## ARCHITECTURAL REVIEW BOARD STAFF REPORT

<b>Project #/Name</b>	<b>ARB-2023-110: Old Dominion Village</b>
<b>Review Type</b>	Initial Site Development Plan
<b>Parcel Identification</b>	05600-00-00-067B0 and 05600-00-00-074A0
<b>Location</b>	1263 Parkview Dr.; 5258 Three Notch'd Rd.
<b>Zoned</b>	Neighborhood Model District (NMD), Entrance Corridor (EC), Flood Hazard (FH), Steep Slopes (Preserved and Critical)
<b>Owner/Applicant</b>	Martin Schulman and Emerald Land LLC/Meridian Planning Group (Tim Miller)
<b>Magisterial District</b>	White Hall
<b>Proposal</b>	To construct 110 dwelling units, comprised of 94 townhouses and 16 single-family detached residences, and associated site improvements on 24.06 acres.
<b>Context</b>	<p>The site is composed of two parcels. The western parcel contains a 3,100 square foot, one-story, brick veterinary clinic and a one-story residence is located on the eastern parcel. (See Figure 1). The development will retain the veterinary clinic, although access and parking serving the clinic will be changed.</p> <p>Overall, the surrounding area is composed of open grassy areas, with mature trees dotting the landscape, tree lines and wooded areas which screen m

**Figure 2:** Areas of the development that are likely to be visible from the EC are identified in yellow.

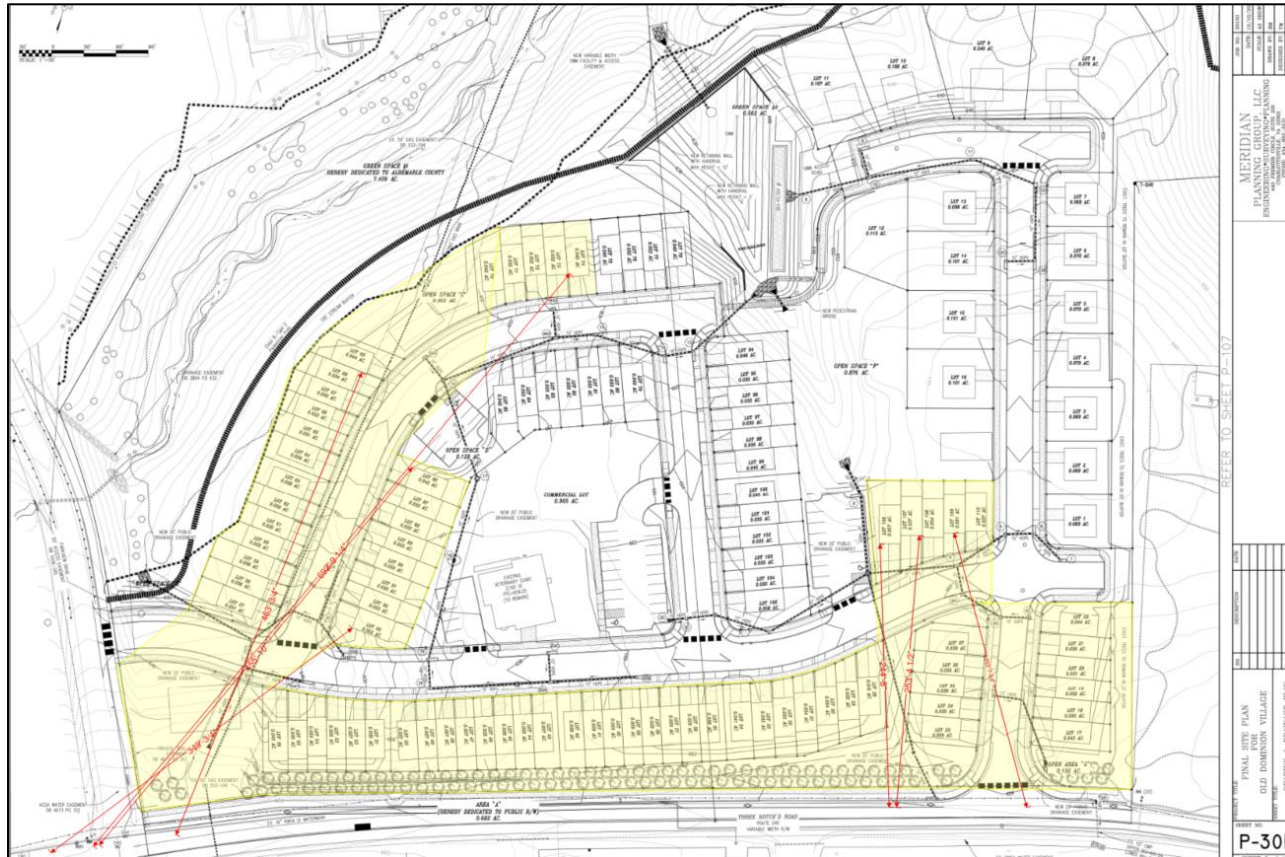
**PROJECT HISTORY AND VISIBILITY** (Figure 2)

Although the initial site plan (Attachment 1) is largely consistent with the approved application plan (Attachment 2), differences include breaks in what was anticipated to be continuous development along the EC frontage. These open areas, near the intersection of Rt. 240 and Parkview Dr. and approximately 40 feet west of the Rt. 240 site entrance, allow views to Lots 57-74, 86-93, and 106-110 located further into the site.
